DELEGATED DECISIONS BY CABINET MEMBER FOR TRANSPORT MANAGEMENT

FARINGDON: B4019 COXWELL ROAD / A417 STATION ROAD – PROPOSED RAISED TABLE MINI-ROUNDBOUT

Project:
PARK ROAD FARINGDON

Drawing Title:
**SECTION 278
MINI ROUNDABOUT
CONSULTATION PLAN**

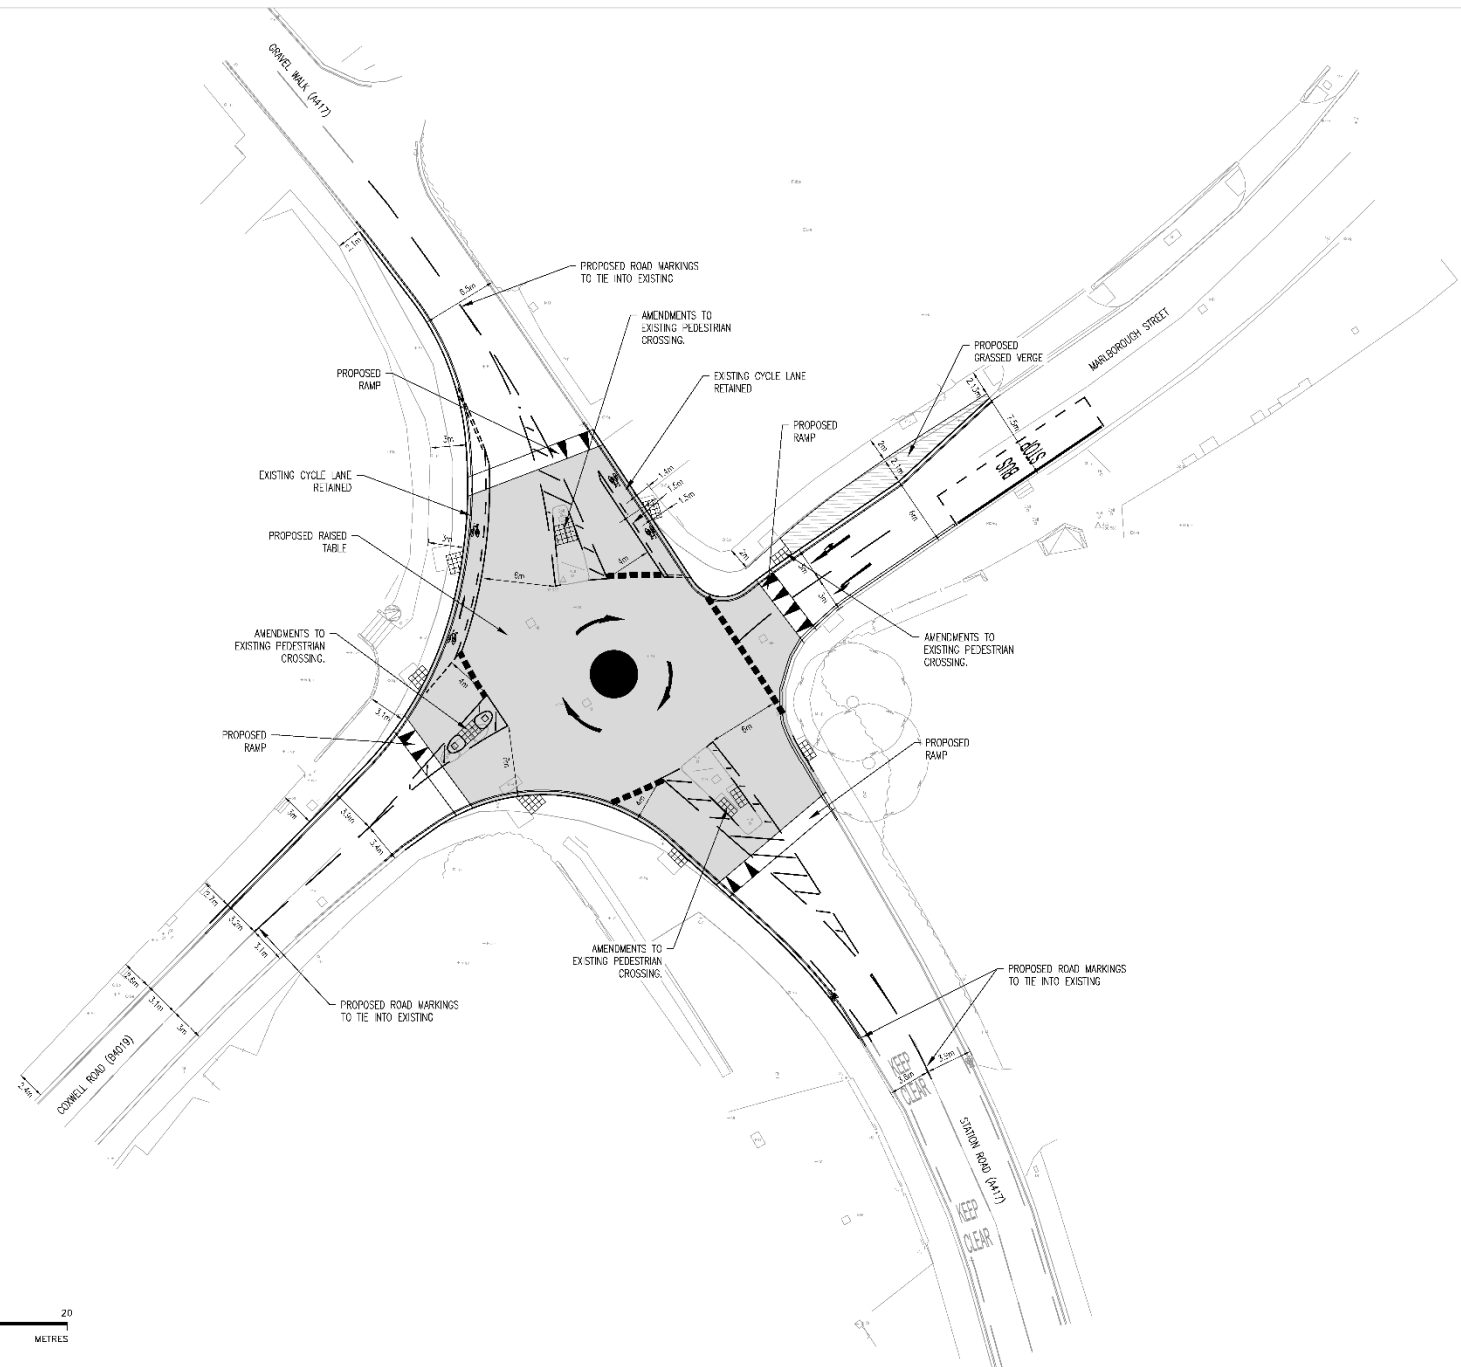
1. This report presents responses received to a statutory consultation on proposals to construct a new traffic calming feature on the A417 Station Road / B4019 Coxwell Road mini roundabout in Faringdon, as shown in **Annex 1**.
2. The traffic calming feature will comprise of a 'Flat Top Road Hump' (with ramp heights of 75mm & gradients of 1:10) to be located at the existing mini roundabout junction, and would extend approximately 20m into its various junctions.
3. Additional improvements to the existing informal crossing points will also be included as part of the proposals.

11. Thames Valley Police expressed no objections to the proposals as advertised.
12. It was asked in the consultation if the proposals would lead to an increase or decrease in the number of road signs, having reviewed the scheme there is no proposed changes to the number of road signs.
13. Comments were made on the cycle provision within the roundabout and scope of the works, unfortunately the scheme approved at planning and secured in the S106 agreement did not include proposed improvements to the cyclist provisions in this area, however it has been negotiated and agreed with the developer to provide better safety for cyclists using the 'slip lane' from Coxwell road (B4019) to Gravel Walk (A417) by placing 'Armadillo' cycle lane raised separators to prevent vehicles entering the cycle lane.

14. Major cycleway improvements and facilities have been provided as part of the main development along Park Road as part of the scheme.
15. Concerns were raised that the narrowing of Marlborough St will lead to difficulties for vehicles turning right at the roundabout, the scheme has undergone detail technical review and tracking analysis and it is confirmed that tightening the radii will not impact vehicles turning right.

16. In addition, concerns were raised that the additional grass verge area could lead to parking issues, there are existing double yellow lines along this section of Marlborough St which prohibits parking on the carriageway and grass verge.

17. It is noted that the Town Council's response stated that the proposed works do not reflect the plans within S106 agreement. The proposed works are almost identical to that secured in the S106 agreement for the development, with the exception of the eastern approach to the mini roundabout from Coxwell Road, in the S106 it is proposed to have a two lane entry to the roundabout, however during the detailed technical review it was not possible to accommodate a dual lane approach due to the width available, having a two lane approach would mean insufficient space for two vehicles to wait alongside each other.

22. Concerns made within the consultation report that it is difficult to cross the road at the designated crossing points, due to the speed and volume of traffic, these proposals will assist with resolving these concerns as the crossings will become raised (flush) and vehicles will slow down due to the ramp's proximity to the crossings.

RESPONDENT	COMMENTS
(1) Traffic Management Officer, (Thames Valley Police)	No objection
(2) Faringdon Town Council	<p>Object</p> <ul style="list-style-type: none"> • Cycle lanes need review. The one going from Coxwell St to Gravel Walk makes a cyclist think they are they are on a protected cycle lane but then suddenly the lane ends leaving the cyclist vulnerable. • Marlborough St narrowing will reduce space for cars turning right and grass verge may be parked on. <p>The plans do not seem to completely match those that are laid out in the s106 agreement that funds this work - This needs to be explained and revisited.</p>

(12) Local resident, (Faringdon, The Pines)	<p>Object – Firstly there is a mistake in your notice, it is the mini roundabout at Station Road and Coxwell Street, not Coxwell Road. This proposal is unsuitable for this roundabout and is not needed. I cannot see how a raised flat top mini roundabout with ramps would help to improve safety here, if anything it is likely to increase the risks of traffic incidents. Approaching the roundabout from Marlborough Street there is already an incline at the junction, so how would an additional ramp onto a raised surface tie in with this and make it safer? The pedestrian crossing points as they are currently and as they are shown on the plan are not great and I would consider to be too close to the</p>

<p>roundabout and should be moved further from the roundabout on their approaches or replaced entirely with a different type of crossing. The cycle lanes as they currently exist and as shown on the plan are utterly pointless. I have lived in Faringdon for my entire life and in 44 years I have never witnessed nor even heard of any incidents at this roundabout. It is just not necessary and the money that would be spent on this scheme could be better spent elsewhere such as fixing some of the roads around the town, Canada Lane is an example of this, of which the condition of the road surface is atrocious. Another option would be to fix and make safer the poorly designed junction at Tesco on Park Road. Coming out of the Tesco car park, the junction has poor visibility, with the junction to Marlborough Gardens opposite and two short turning lanes in the middle of the road. This is a more dangerous junction, where to exit the Tesco car park you often have to take your life in your hands. I have seen many near misses here and think it should probably be prioritised over the proposed scheme which would do nothing to make the mini roundabout at the junctions of Station Road and Coxwell Street safer.</p>

(16) Local resident, (Faringdon, Coxwell Street)	<p>Partially support – I don’t think the plan addresses the issues, we live on Coxwell street so use the station road crossing a lot. The main issue that we see is that drivers approaching the mini roundabout from the 9arlborough street side don’t look left before turning left so as a pedestrian it does not feel safe to cross. It’s not always possible to tell which direction cars are turning so you have to wait until there is no traffic turning left from 9arlborough street to station road. Moving the existing crossing 5-10 metres along station road would make this a safer crossing for pedestrians</p>

<p>Partially support – There is insufficient information. le Colour of road surfaces. Explanation of grassed area – currently a seating area, gravelled</p>
<p>(21) As part of a group/organisation, (Farcycles, community cycling charity, Coxwell Road)</p>	<p>Partially support</p> <ol style="list-style-type: none"> 1. The ramps are definitely a good idea to slow traffic approaching the roundabout. 2. I think the cycle lanes are pointless, and even frankly dangerous – the one going from Coxwell St to Gravel Walk makes a cyclist think they are they are on a protected cycle lane but then suddenly finds the lane ends and a car comes across your path. I've had drivers follow me turning left and use the opportunity to overtake on the roundabout and cut in at the end of the cycle lane. 3. I cannot understand why Marlborough St should be narrowed, just after the bus stop? This will hold up traffic and it makes the 2 lanes very narrow at the top with cars squeezing past cyclists. What is the point of the grass verge? Other grass verges in Faringdon just get driven on! 4. I like the markings of 2 lanes going up Marlborough St to the roundabout.
